**RE: Amadeo Residence at 101 Silver Spring Road,  
Wilton - Amendment**

RE: 101 Silver Spring Road, Wilton, CT – Site Plan Amendment to Resolution #0622-48WET; WET#2802

Re: Wetland Impact Assessment  
Proposed Driveway Improvements  
101 Silver Spring Road, Wilton, CT

1 DEMOLITION & PREPARATION PLAN  
SCALE: 1" = 20' - 0"

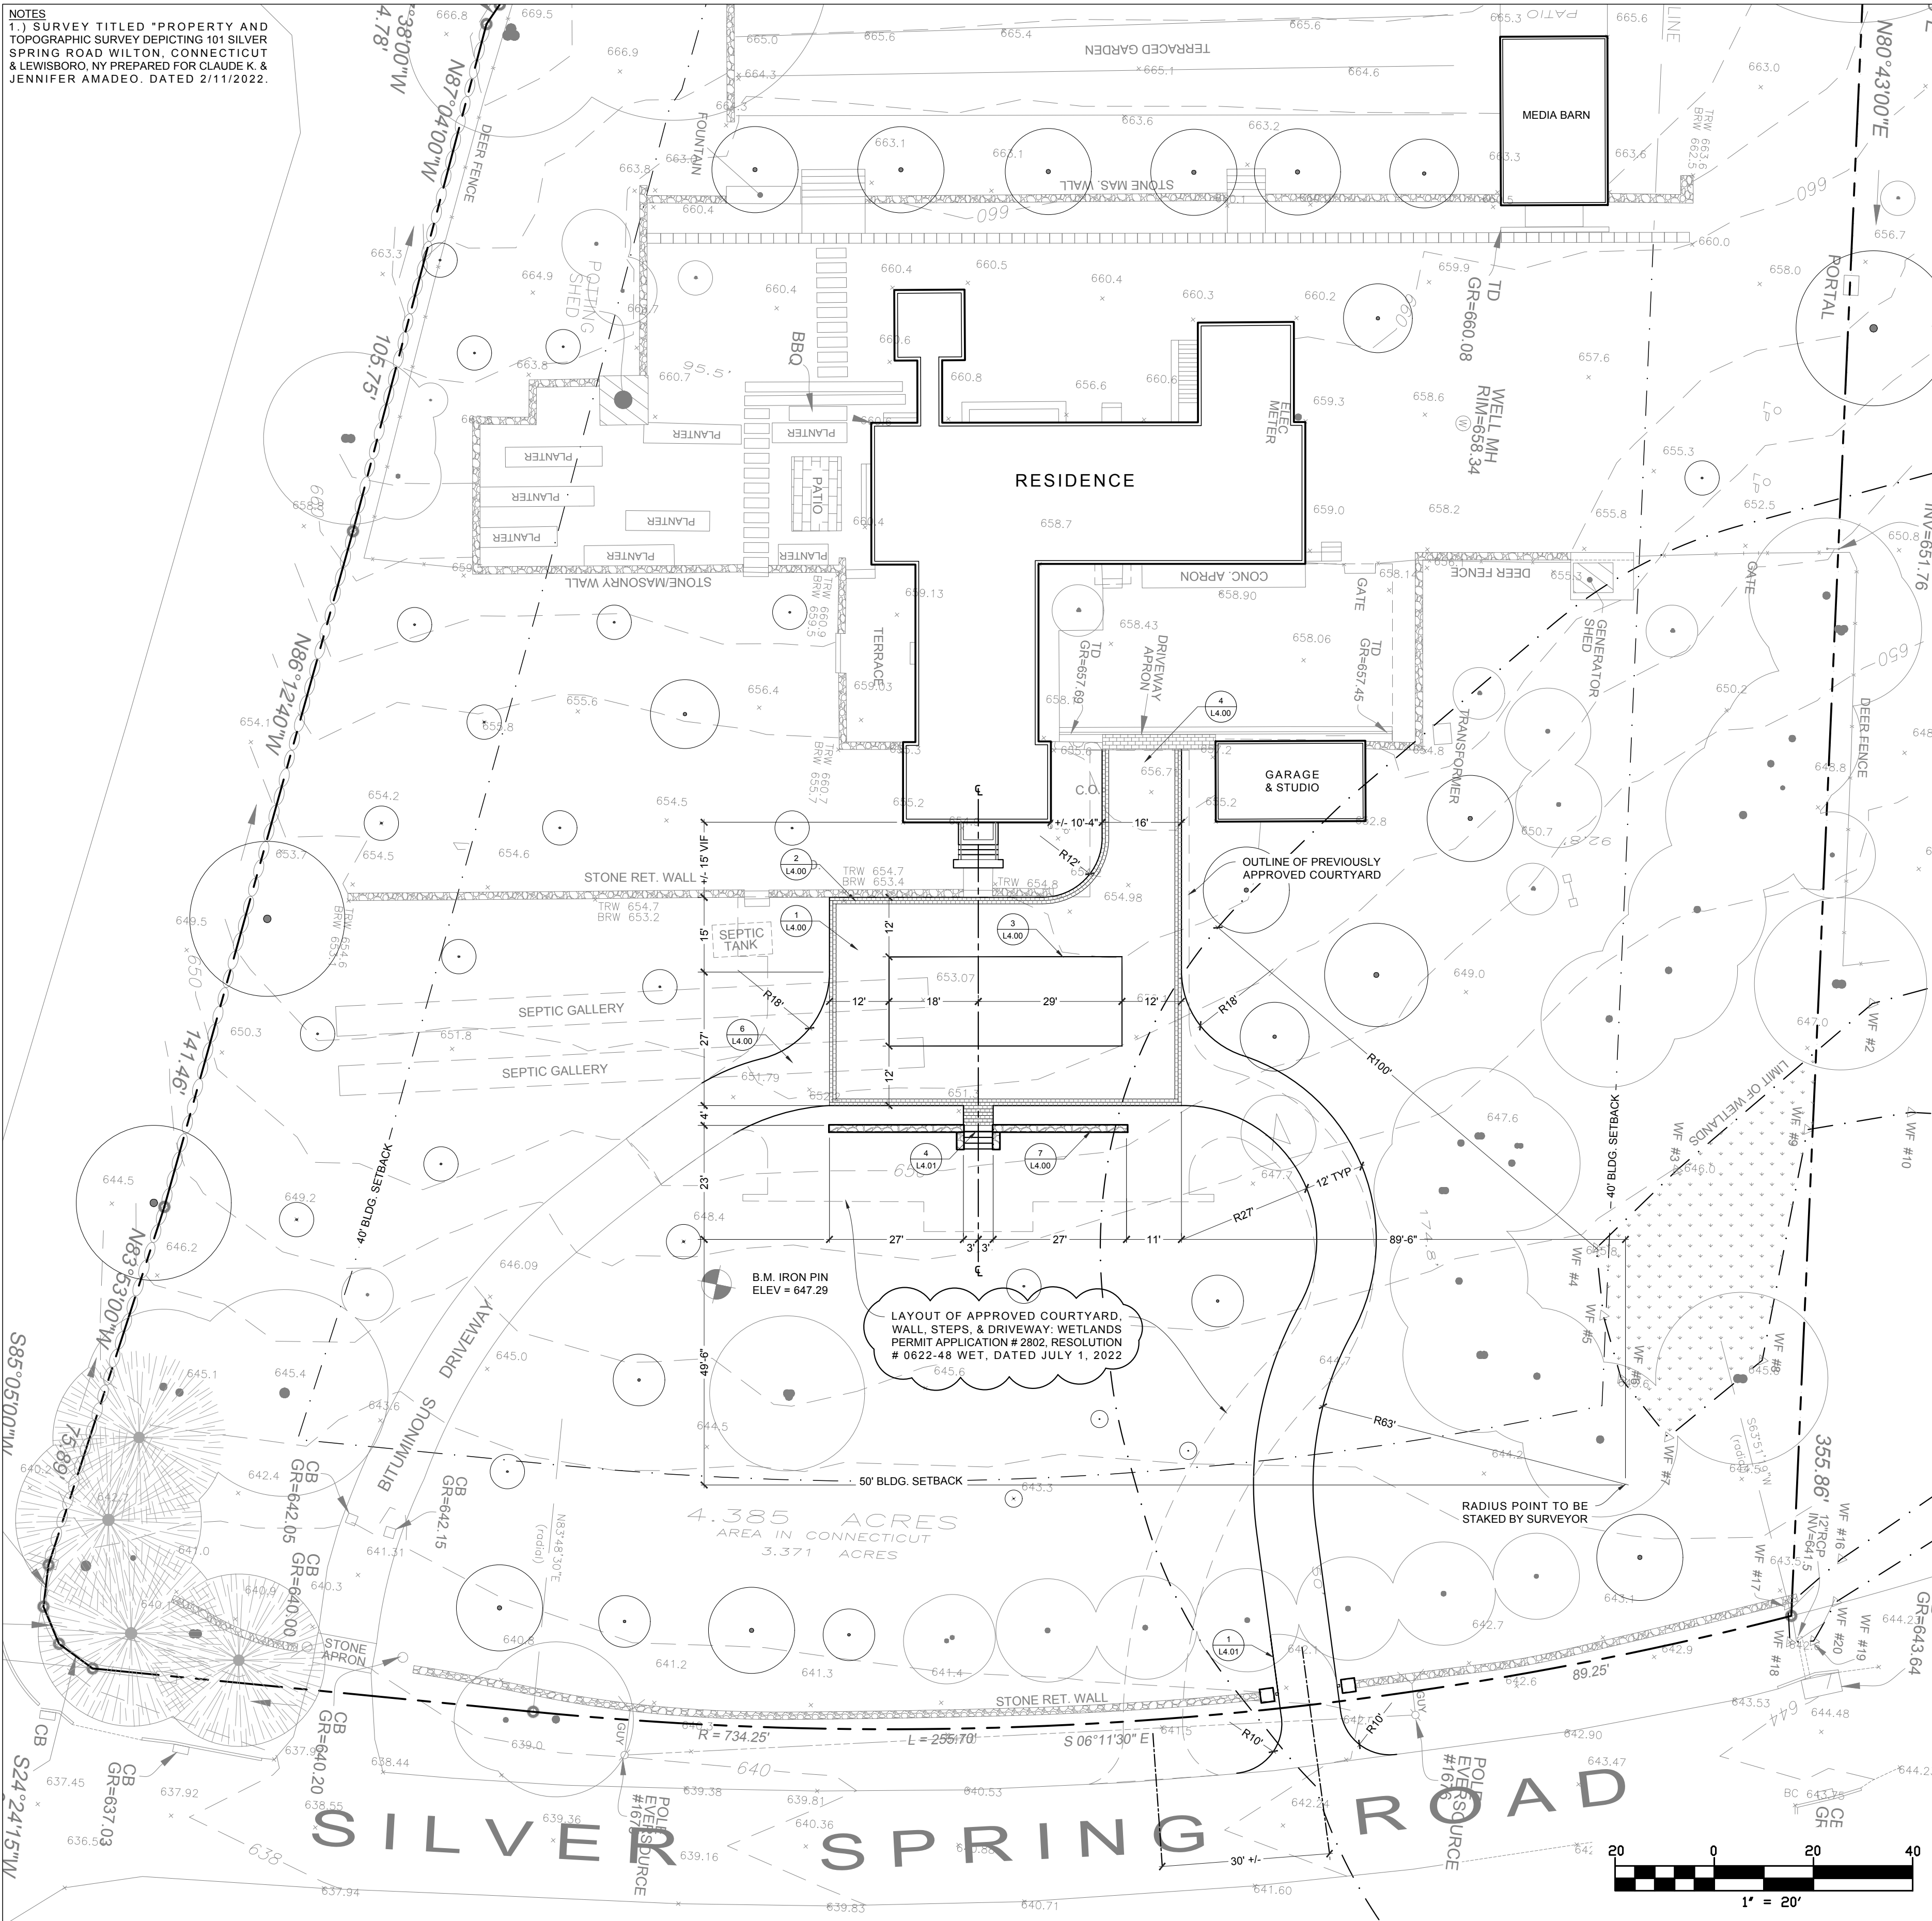
After further design development, we would like to request slight modification to the original drive layout. All previously proposed and approved activities would remain. The proposed design modifications would include an overall reduction in the parking court size and shifting / straightening of the drive exit loop, approximately 30' to the north along Silver Spring Road. The resulting layout will, at its closest approach, be approximately 45 feet from inland wetlands. No work is proposed in the inland wetlands.

1 GRADING PLAN  
SCALE: 1" = 20' - 0"

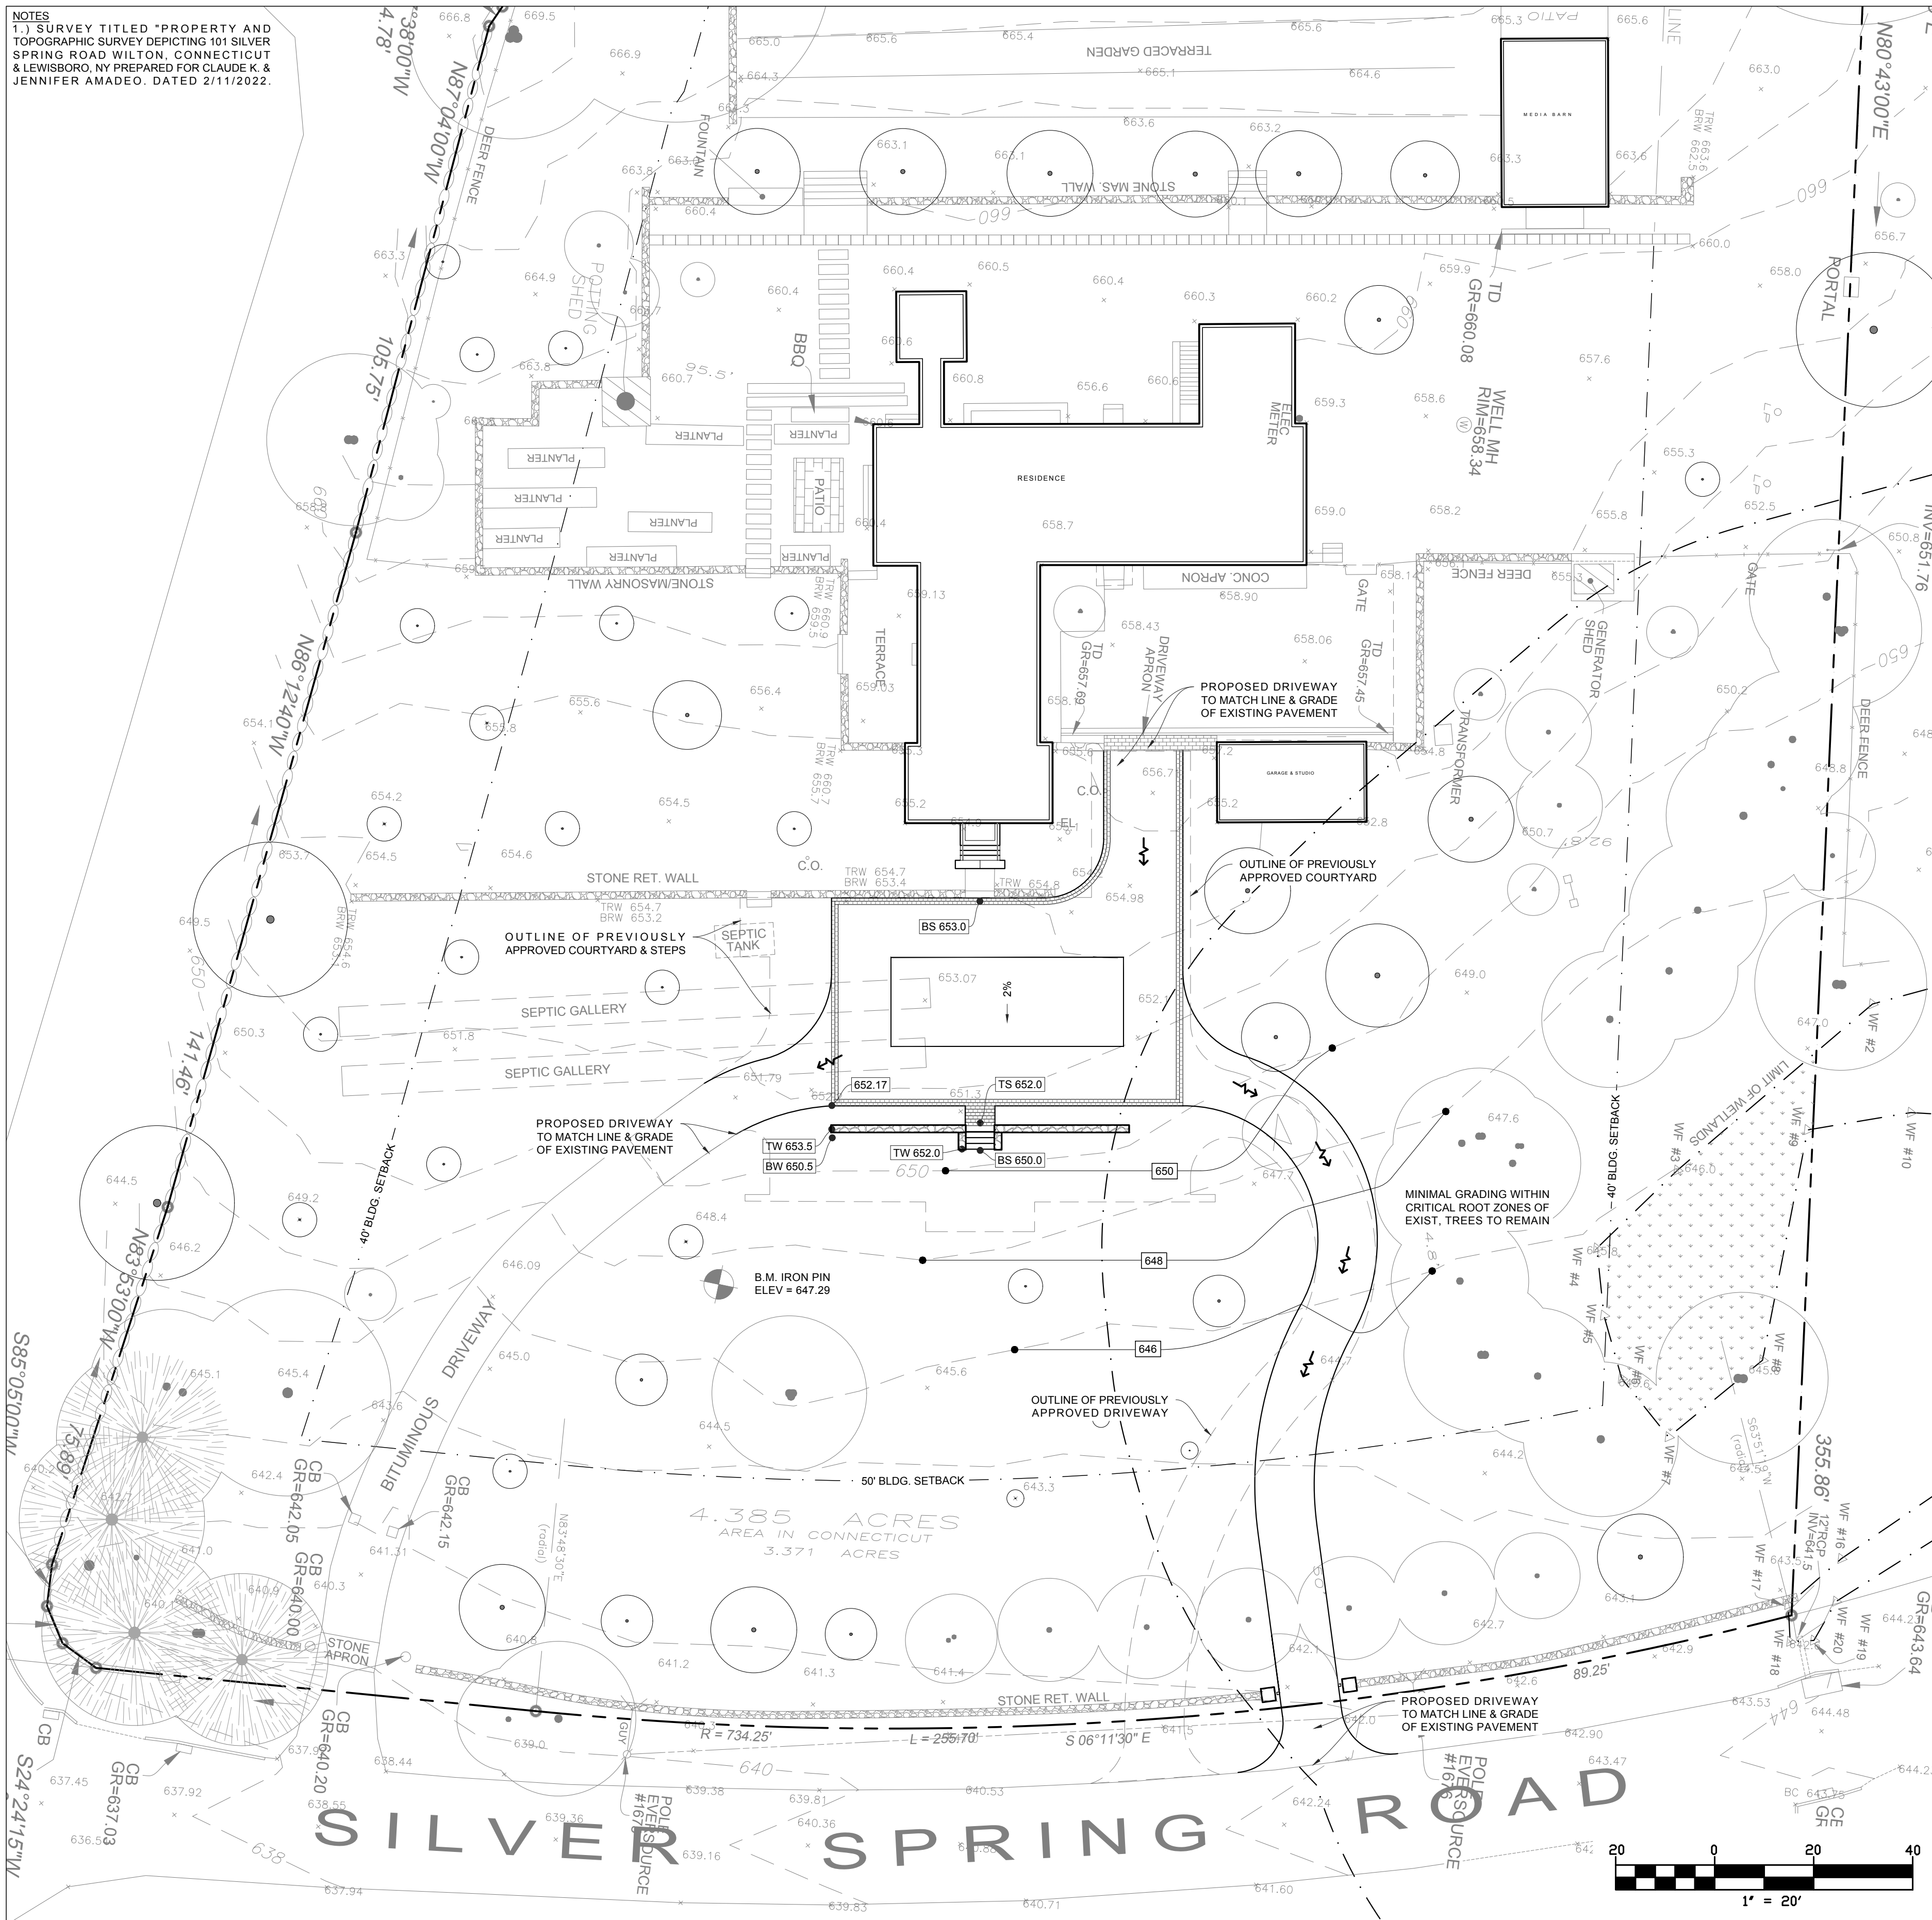
The approved plan involved the expansion of the existing driveway to include an exit loop connecting back to Silver Spring Road, addition of a pervious gravel courtyard to the driveway, installation of several systems of precast subsurface stormwater infiltration galleries and other related site improvements as well as landscape improvements. The new proposed design includes all of these approved activities, save for the modification of the exit loop driveway that will site it closer to inland wetlands. The new proposed layout will straighten the exit drive and will, at its closest approach, be approximately 45 feet from inland wetlands.
